UNITED STATES PATENT AND TRADEMARK OFFICE

APPLICATION NO.	FILING DATE	FIRST NAMED INVENTOR	ATTORNEY DOCKET NO.	CONFIRMATION NO.
10/582,032	08/08/2006	Mats Johansson	P/1228-209	2006
2352 7590 10/19/2007 OSTROLENK FABER GERB & SOFFEN 1180 AVENUE OF THE AMERICAS NEW YORK, NY 100368403			EXAMINER LUONG, VINH	
			ART UNIT 3682	PAPER NUMBER
			MAIL DATE 10/19/2007	DELIVERY MODE PAPER

Office Action Summary

ATTACHMENT

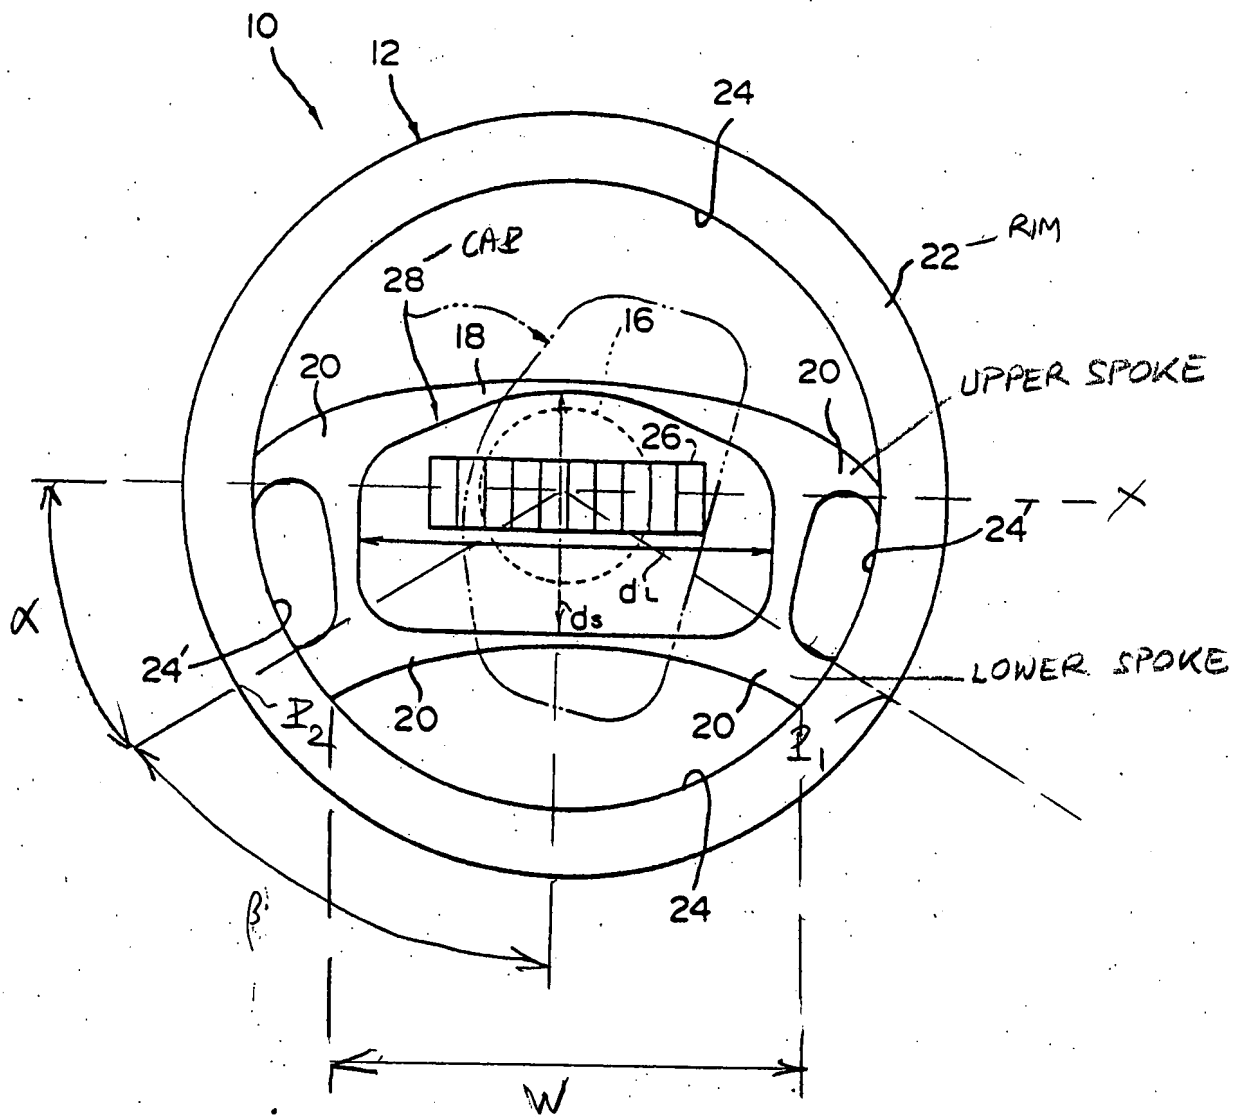
two lower spokes 20 also extending between the signal cap 28 and the rim 22, the lower spokes 20 having an upper edge (see Attachment hereinafter "Att.");

the two lower spokes 20 are shaped and positioned to be graspable by a normal man's hand, the lower spokes 20 extend from positions around the rim 22 so that points (P_1 and P_2 in Att.) that are in line with the upper edge of the respective lower spokes 20 on the outer surface of the rim 22 are located between 30° and 60° (see angle α in Att.) below the horizontal symmetry axis on either side of the vertical symmetry axis Y of the steering wheel 10, and the upper edge of the lower spokes 20 is in line with the respective points (P_1 and P_2 in Att.) and forms an angle (β in Att.) of between 62° and 82° with the vertical symmetry axis Y of the steering wheel 10, and a multifunctional switch module 26 including control buttons operable for remote actuation of vehicle functions, the module 26 is located between the two lower spokes 20 on the signal cap 28, whereby the driver can operate the module 26 while grasping the lower spokes 20. Ibid. col. 4, line 57+.

Regarding Claim 2, the two points (P_1 and P_2 in Att.) are situated about 30° below the horizontal symmetry axis X (FIG. 5) on either side of the vertical symmetry axis Y of the steering wheel 10. To change the instant angle to 40° would have been a matter of choice in design since the claimed structures and the function they perform are the same as the prior art. *In re Chu*, 66 F.3d 292, 36 USPQ2d 1089 (Fed. Cir. 1995) citing *In re Gal*, 980 F.2d 717, 719, 25 USPQ2d 1076, 1078 (Fed. Cir. 1992). See also legal precedent regarding changes in size/proportion in MPEP 2144.04.

Regarding Claims 3 and 4, the angle (β in Att.) from the vertical symmetry axis Y of the steering wheel 10 to the respective points (P_1 and P_2 in Att) are about 60° . To change this angle to between 67° and 77° or 72° would have been a matter of choice in design since the claimed structures and the function they perform are the same as the prior art. *In re Chu*, *Ex parte Smith*, and MPEP 2144.04, *supra*.

Regarding Claims 6 and 7, a width (W in Att.) of the graspable part of the upper edge of the lower spokes 20 is measured at a certain mm. To change this width to between 65 mm and 105 mm or about 85 mm would have been a matter of choice in design since the claimed structures and the function they perform are the same as the prior art. *In re Chu, Ex parte Smith*, and MPEP 2144.04, *supra*.
